Technical Note

Proposed Residential Development

Stansty Chain Road, Wrexham

Our reference: LB/220743/TN01 Rev E

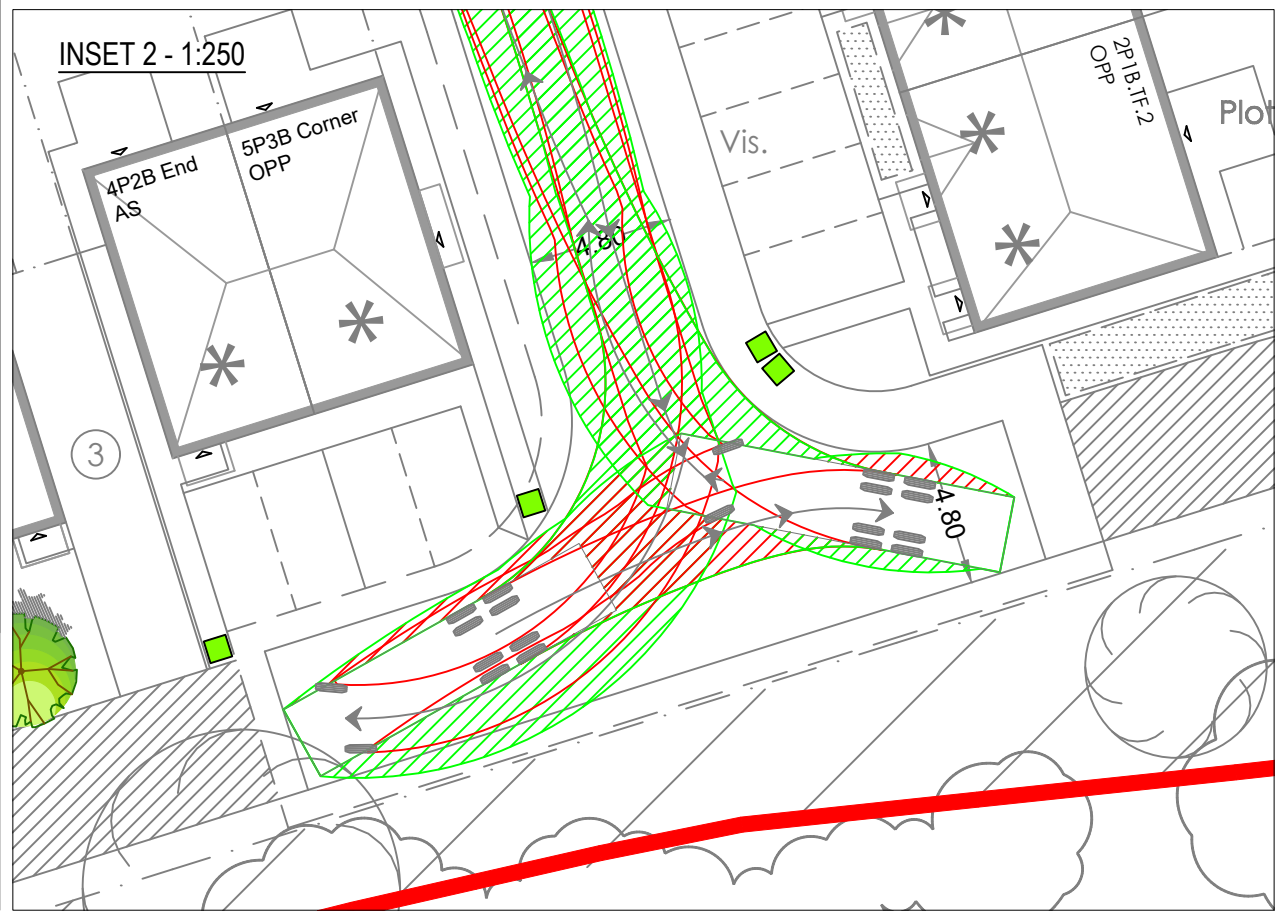
The site access is shown as allowing only right turns from the site access road. The access plan shows no right turn into the site. The LHA agree that the right turn into the site should not be permitted, but are concerned that the arrangement as shown may still offer the ability for a non-complying driver to make the right turn in. **A more self-enforcing configuration is therefore required to be demonstrated.**

As stated in the LHA consultation response in August 2024, the proposed access road layout is acceptable in principle. However, it was requested that the developer ensure a width of 5.5m is maintained throughout the length of the access roads alongside 2m wide footways (to both sides) where there are residential frontages. The site layout does not contain any dimensions, so it is not possible to confirm if this is the case. A drawing showing the dimensions of the internal road network including turning heads should be provided. It was stated in the previous LHA response that some of the turning heads provided do not meet the WCBC standards and therefore should be amended to ensure vehicles, including Refuse Collection Vehicles (RCV) can turn safely within the site. It is recognised that the site layout plan has changed, however, no dimensions have been shown on the site layout drawings and therefore it is not possible to confirm if the turning heads are designed to standard. The applicant should submit a drawing with the appropriate dimensions clearly shown so that these can be checked by the LHA. The swept path assessments provided in the TS clearly show the RCV over-running the footway in places. This is unacceptable from a road safety perspective and is not considered safe. The dimensions of the turning head and bends should be amended to ensure a refuse vehicle can turn without overrunning the footway.	The revised site layout plan provided in Appendix C includes the dimensions of the roads including turning headings and demonstrates the internal spine road has a carriageway width of 5.5m and footways with widths of 2.0m either side. Swept path analysis of a refuse collection vehicle (RCV) is shown on drawings SCP/220743/ATR02 Rev F and SCP/220743ATR03 Rev F provided in Appendix D and demonstrates that a RCV can turn safely within the site. Whilst there is some minor body overhang of the RCV, pedestrian trips at these locations will be low, particularly at locations where there is overhang of service strips opposed to footways.

The LHA has previously raised concerns regarding the proximity of the proposed private shared drive access to the main site entrance onto Mold Road, a classified road. The current layout places this access point within 15 metres of the junction, which is considered unacceptable on highway safety grounds. This requirement is supported by principles outlined in Manual for Streets (MfS), particularly in Section 7 – Street Geometry, which emphasizes the need for adequate spacing between junctions and private accesses to: • Minimise conflict between turning movements. • Maintain clear visibility for all road users • Ensure safe operation of the junction, especially on classified roads with higher traffic volumes. While MfS does not prescribe a fixed minimum distance, the 20m minimum spacing ensures:	The proposed private shared drive access has been setback 20m from the main site entrance as shown on the revised site layout plan provided in Appendix C.

Internal Site Layout Linked to the above, a plan showing the boundary treatment for all properties that border the internal road that is to be adopted, must be provided to ensure that any boundary treatment will not affect vehicular or pedestrian intervisibility.	It is confirmed that the boundary treatment will not impact on vehicular or pedestrian visibility, with a plan showing the proposed boundary treatment to be submitted under separate cover.

The drawing provided in **Appendix B** shows the revised access arrangement which provides an increased length on the right turn arrangement within the central reserve and additional hatchings along the A541 Mold Road northbound in order to make the turning manoeuvre more arduous and deter non-complying drivers attempting to turn right into the site.

The access will include a footway/cycleway either side of the carriageway which will tie into the existing facilities along the eastern side of the A541 Mold Road. Signage will be provided at the access to inform users of the shared footway/cycleway.

• Safe ingress and egress for vehicles • Reduced risk of rear-end collisions or turning conflicts. • Compliance with visibility splay requirements (e.g. 2.4m x 25m for internal junctions) In this context, a suggested 20m setback is necessary to ensure the safe and efficient operation of the site access and to align with both national guidance and local highway design standards. The updated site layout submitted with the TS has not addressed the LHA previous comments regarding the private shared drive within 15m of the main site access onto Mold Road which is a classified road. As previously stated, this is not acceptable on highway safety grounds, and it should be set back to beyond 15m but a recommended 20m.	
Internal Site Junctions There are a number of proposed internal site junctions. Commensurate visibility splays must be provided for all internal access junctions. It is noted that some internal access junctions have trees to one or both sides. It is requested that areas within the visibility splay must be free of items in excess of 600mm in height.	Internal visibility splays of 2.0m x 25m are shown on drawing SCP/220743/SK04 Rev D provided in Appendix E. Visibility splays will be free of items in excess of 600mm in height and this can be conditioned.
